ROTAX. SERVICE INFORMATION

5 UL 90-E

Disturbance of tachometer 966 072 for Rotax 503 UL C.D.I. and 582 UL C.D.I. with DUCATI ignition unit

This Service Information, edition December 1990, replaces edition Sept. and Nov. 1990.

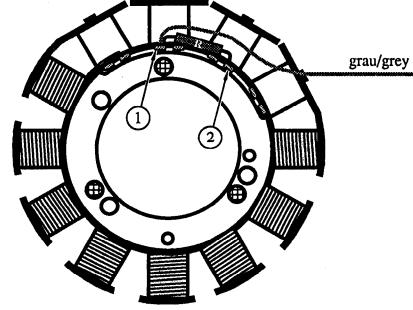
- 1) Remove stator 996 845 from the stator plate.
- 2) Scrap off insulating compound from both ends of the resistor (pos.1 and pos.2), which is on the back side of the stator.
- 3) Unsolder both ends of the resistor (pos.1 and pos.2) as well as the grey cable (pos.1).
- 4) Shorten the grey cable by approx. 20 mm and dismantle a short piece of the grey plastic insulation to get a clean new soldering connection.
- 5) Re-solder the grey cable in the connection pos.2.

Take care of good soldering connection between the grey cable and the lead coming out of the coil, as well as of perfect fixation on the connection boss.

6) Re-insulate the soldering point (pos.2) e.g. with PU-Glue (Sikaflex-255) 297 710 or Araldit.

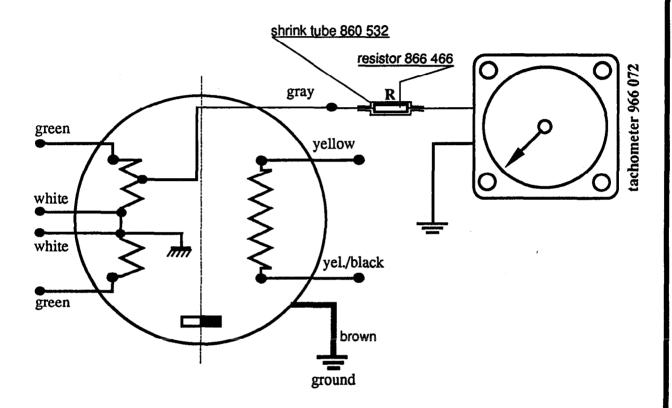
8) An external resistor of 1 k Ω (866 466) must be installed in the grey cable and protected by a shrink tube (860 532) as shown below. This resistor replaces the one in the stator and is necessary to protect the tachometer 966072.

ATTENTION: If the resistor 866 466 gets installed without removing the resistor from the stator (coil set), the tachometer indicates a higher r.p.m. drop when checking a single ignition circuit.
